Cleanup Action Plan Addendum

Riverside HVOC Site

Prepared for
City of Bothell

February 2025 DRAFT

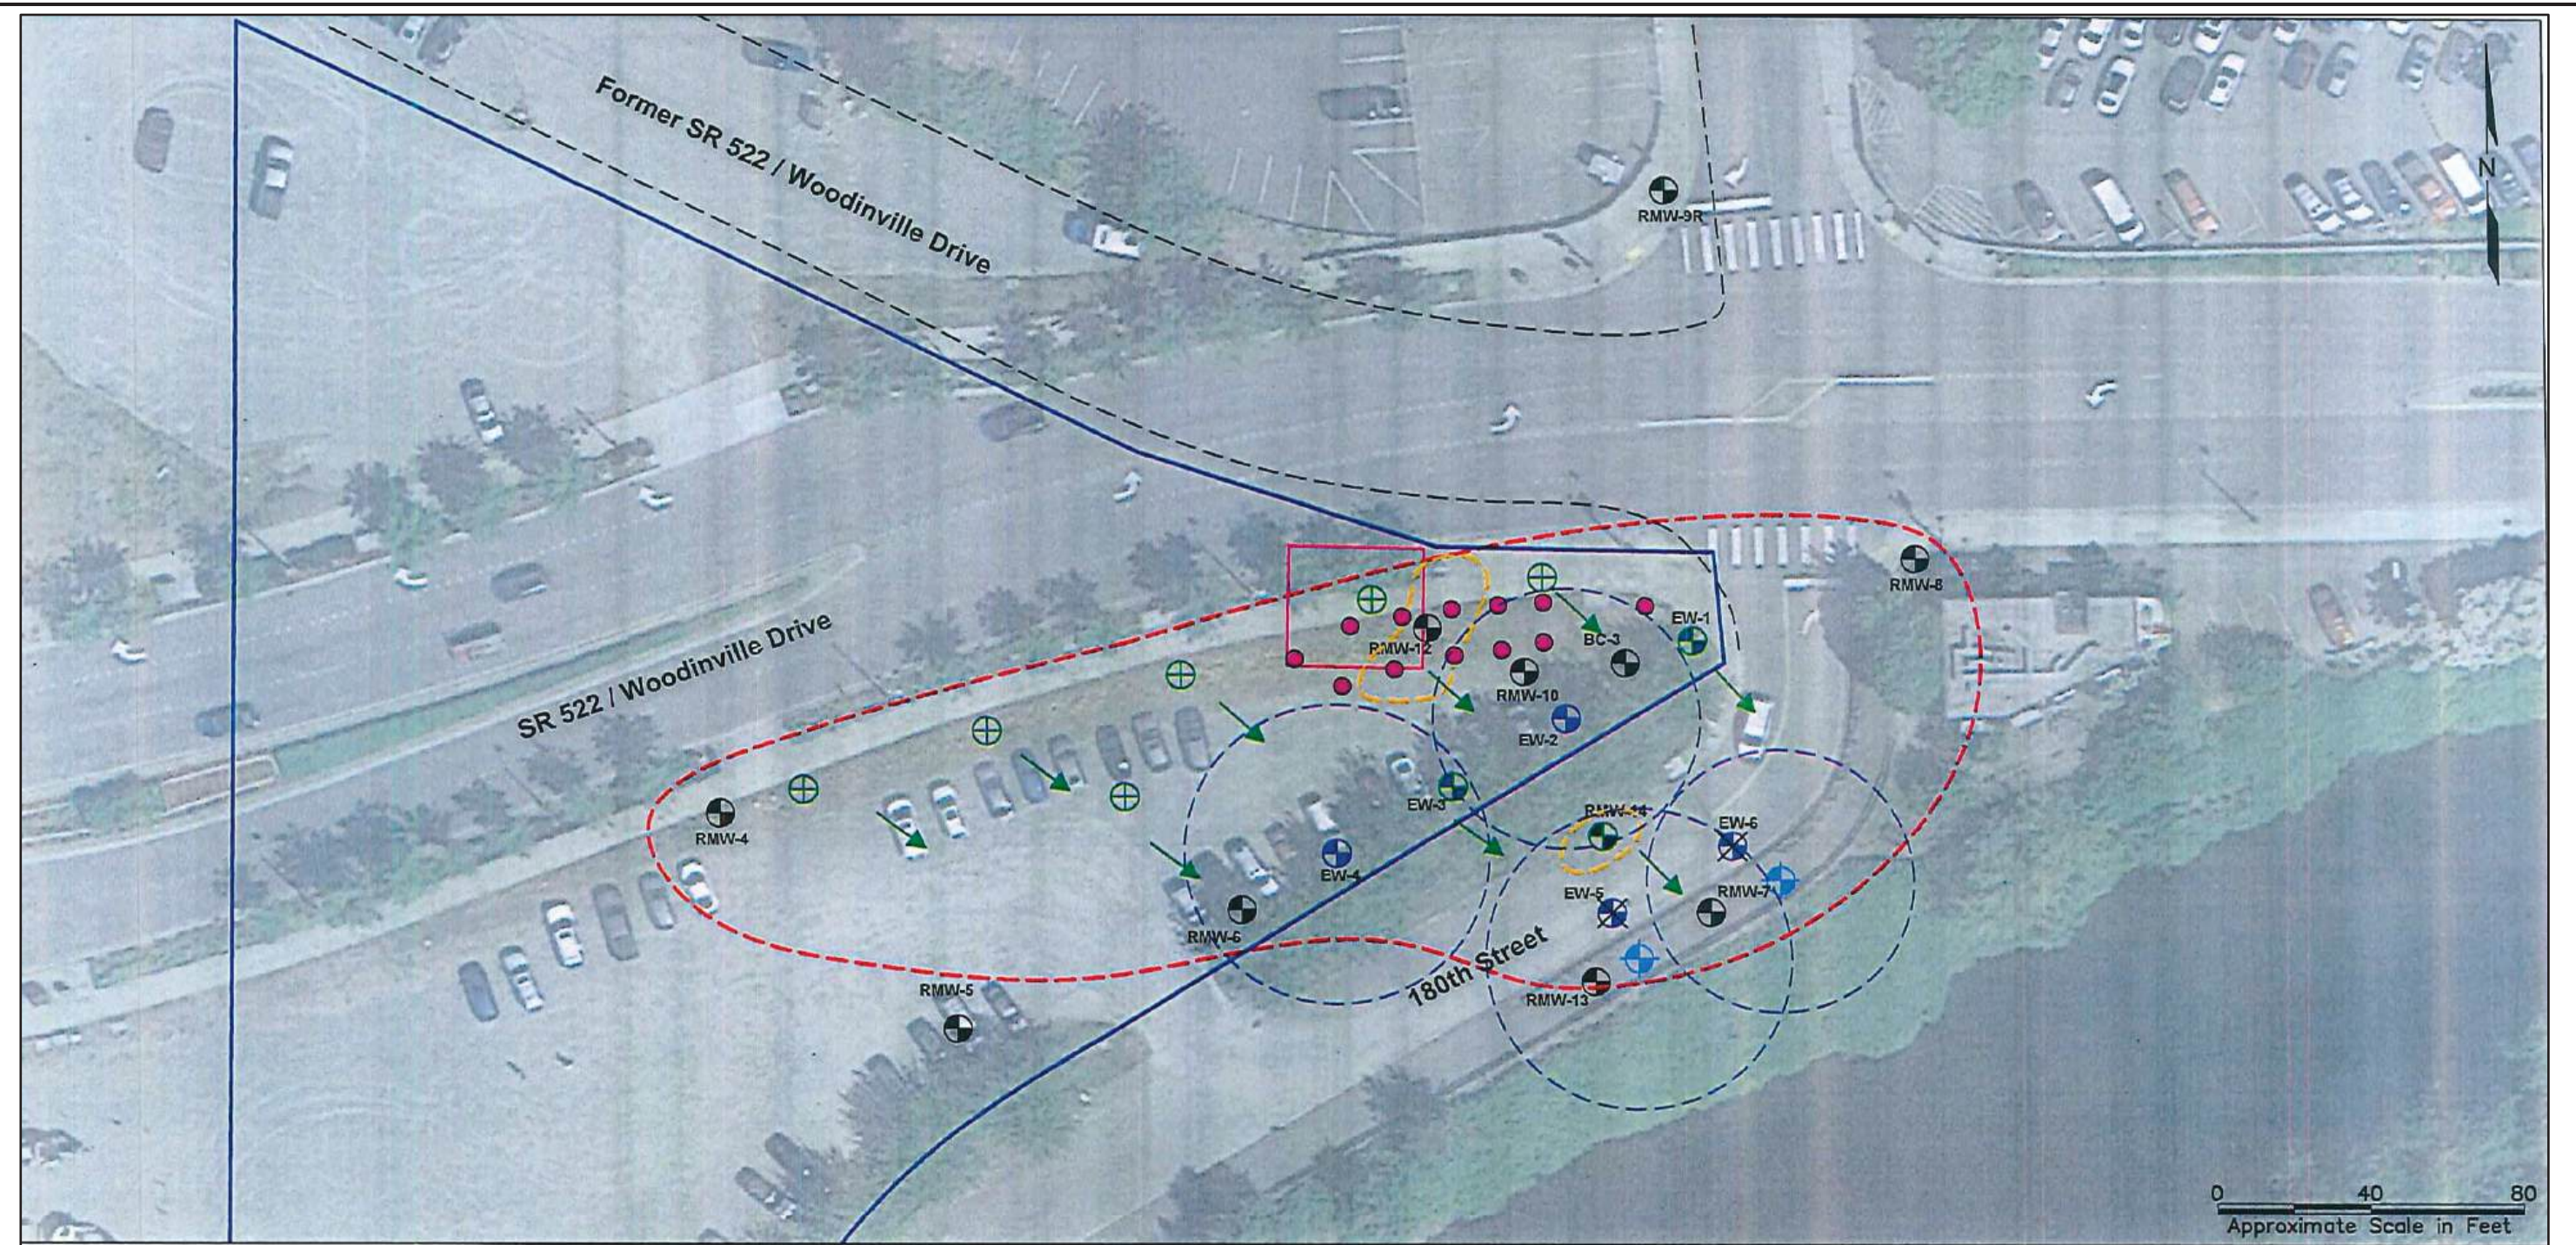
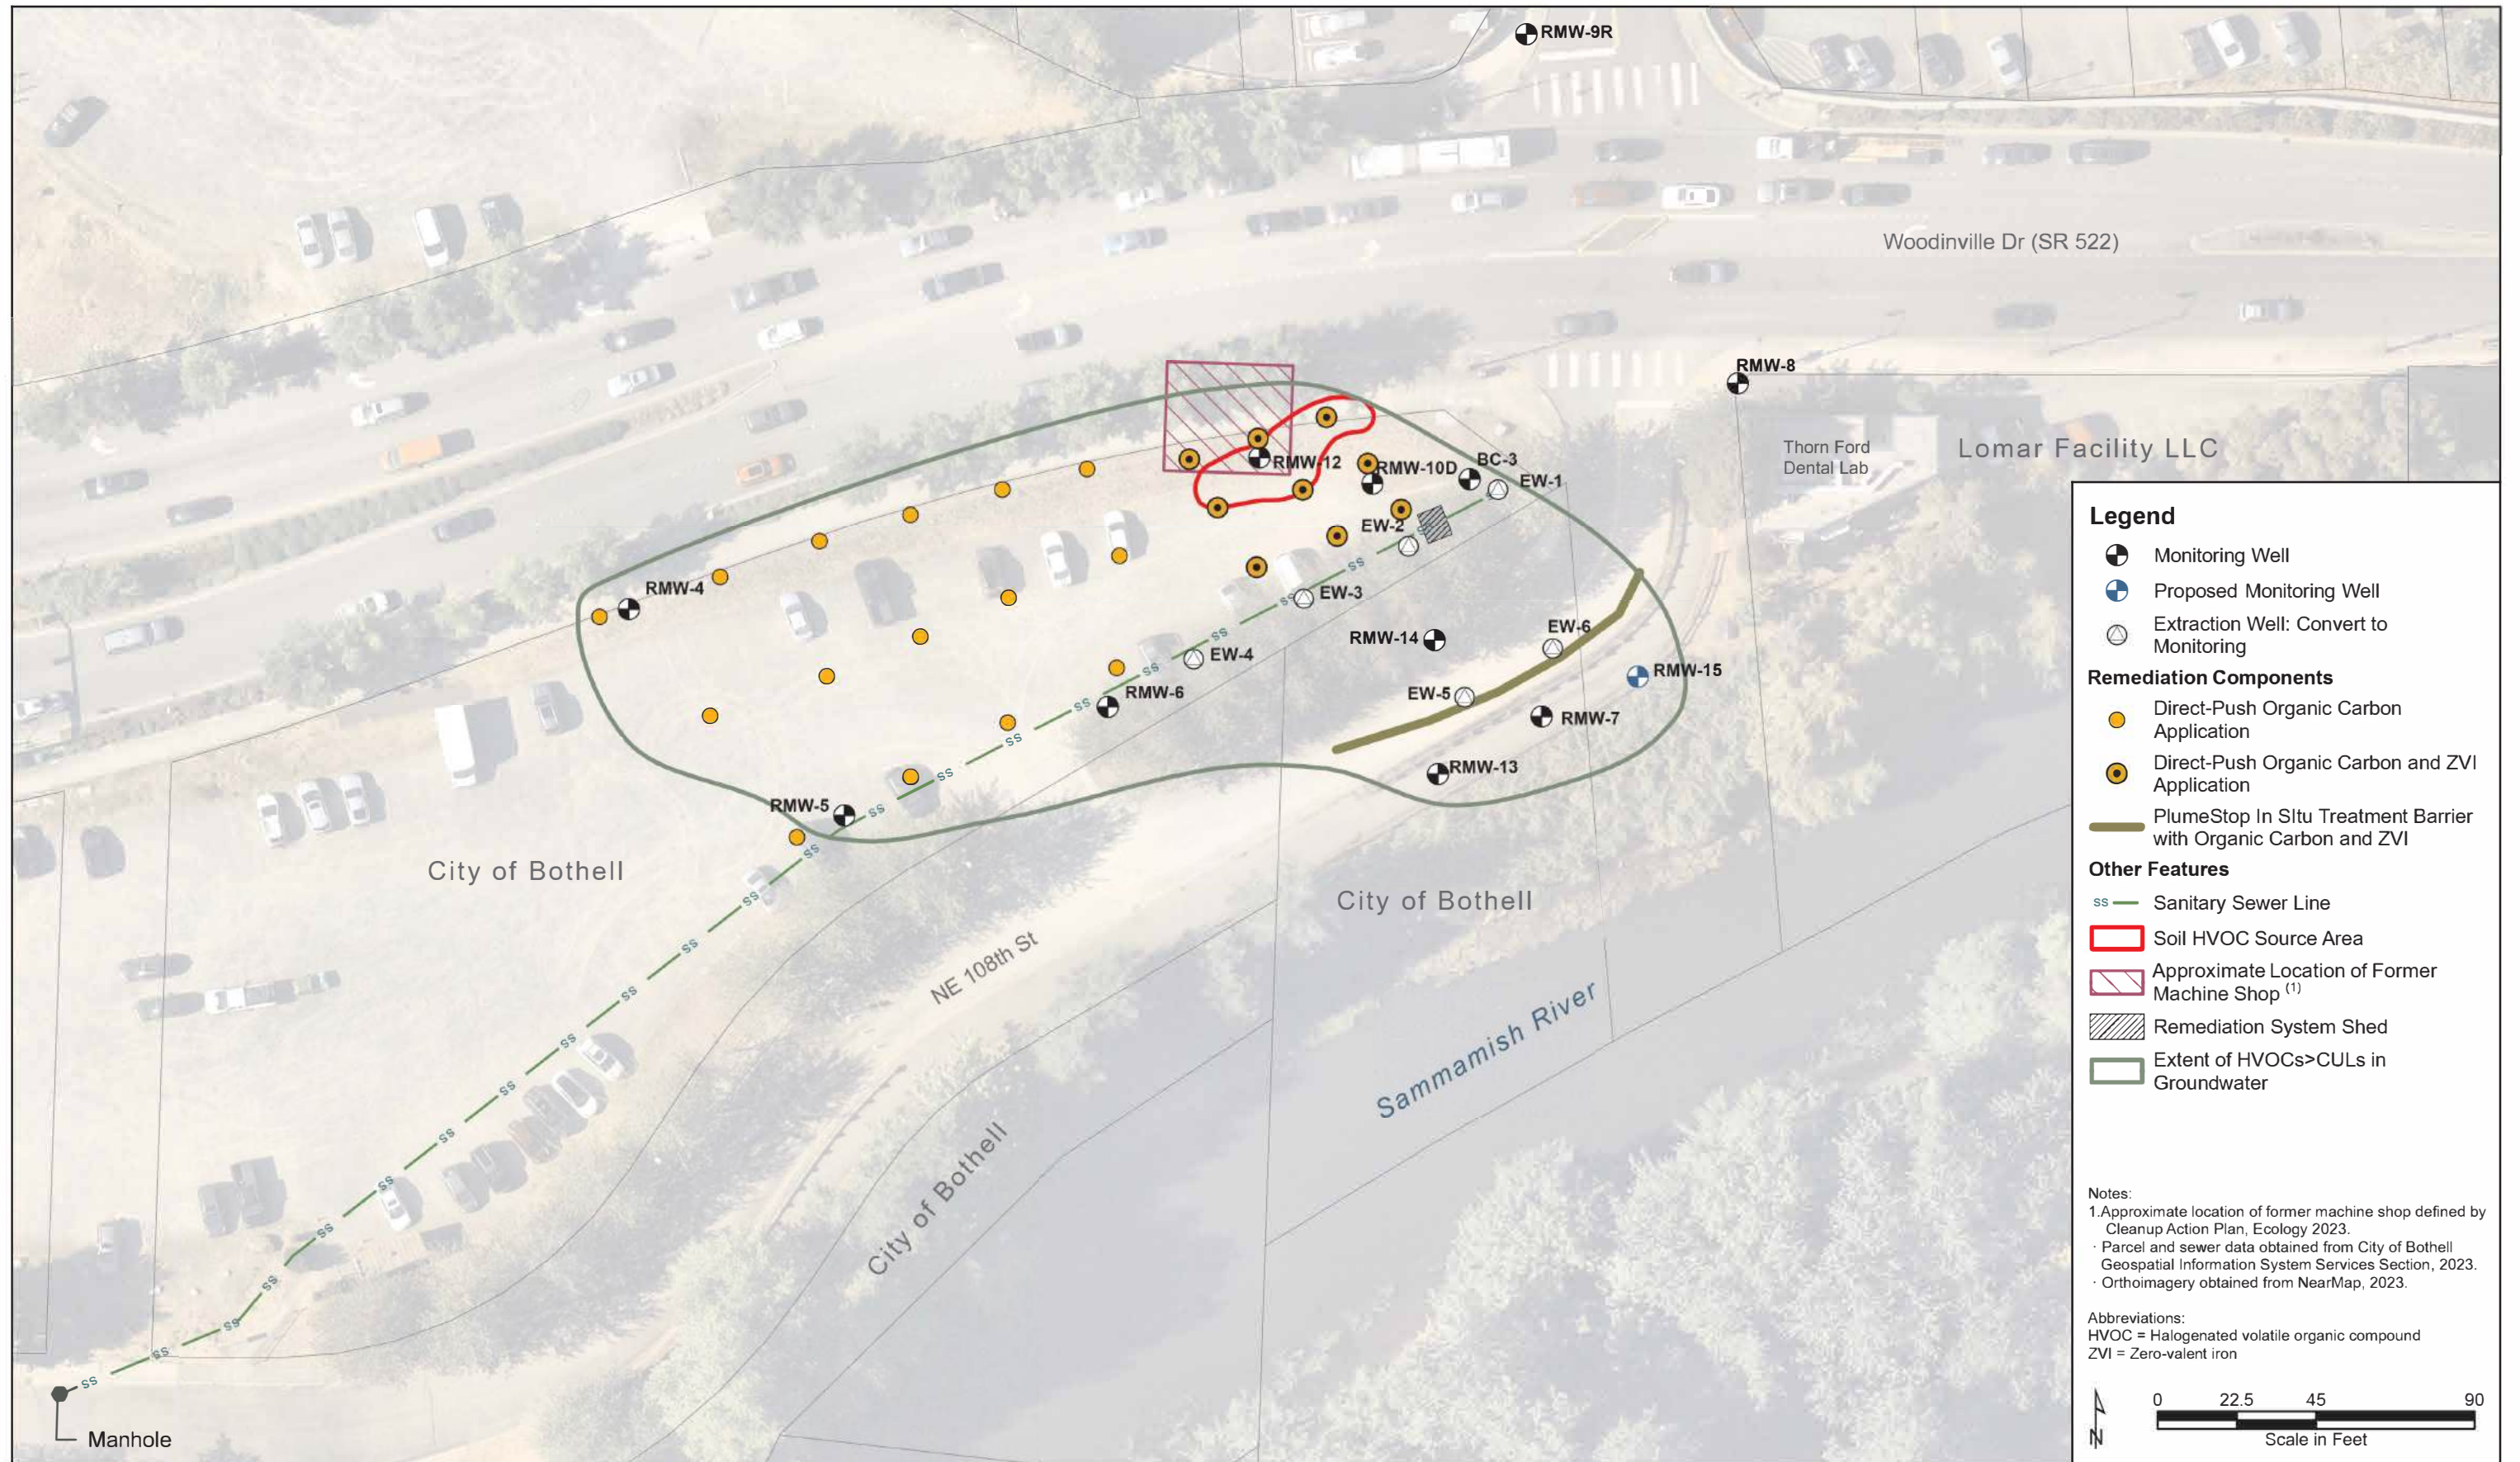
- SVE is eliminated.
- Soluble organic carbon and *Dehalococcoides* treatment in the source area is achieved by direct-push injection, which is supplemented with zero-valent iron (ZVI). A lesser amount of supplemental ZVI is also added in the western plume.
- Downgradient soluble organic carbon and *Dehalococcoides* treatment are supplemented with ZVI and colloidal activated carbon (such as PlumeStop) to form in situ treatment barriers.
- A controlled-release source of organic carbon is used.

The elements of the revised cleanup action are shown on Figure 3.2. This alternative supplements source area treatment with ZVI to achieve prompt abiotic degradation of PCE and TCE and ensure ongoing reducing conditions to promote anaerobic biodegradation. The addition of ZVI, combined with a controlled-release form of organic carbon, allows for a single direct-push application of the treatment materials in lieu of recirculation to degrade the remaining HVOC mass. The addition of colloidal activated carbon downgradient is designed to adsorb HVOCs and allow longer contact time with the treatment materials, which will allow for more rapid cleanup of downgradient groundwater. A double row of injections is assumed in order to form a highly effective barrier. The estimated restoration time frame for this cleanup action is 3 years. The estimated cost for this cleanup action is \$1,655,362.

Based on the analysis described in the previous sections, Ecology has eliminated SVE treatment of vadose soil and revised the in situ groundwater treatment as shown on Figure 3.2 to address contamination in saturated soil and groundwater at the Site. This revised cleanup action will remediate contaminants in saturated soil and groundwater, treat contaminated groundwater flowing through downgradient in situ treatment barriers before reaching the Sammamish River, and protect human health and the environment at reduced cost and faster restoration time frame than the 2023 CAP cleanup action.
